Site Plan

RICHMOND ROAD
MARSDEN PARK
URS20371
RESIDENTIAL SUBDIVISION
LOT 3 DP 1225885
ELECTRICAL RETICULATION

A1 509324 A
Sheet No 1 of 4 Sheets

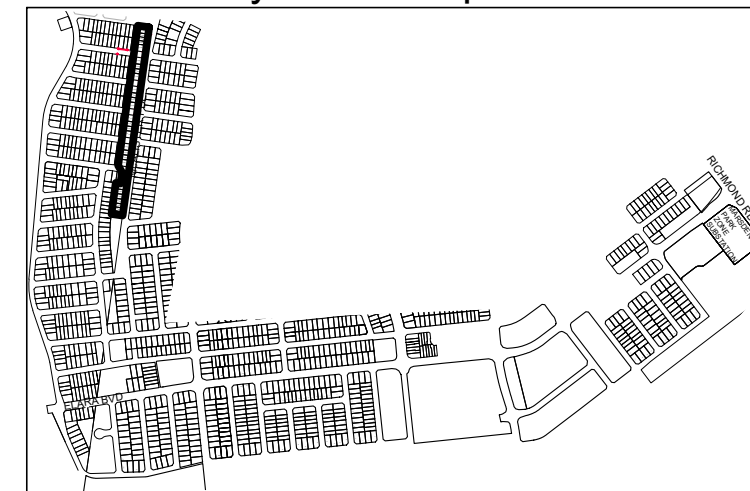
ALIGNMENT OF ROAD BEGINNING
AT LOT 2405 CHANGED TO MATCH
CORRESPONDING SIDE.
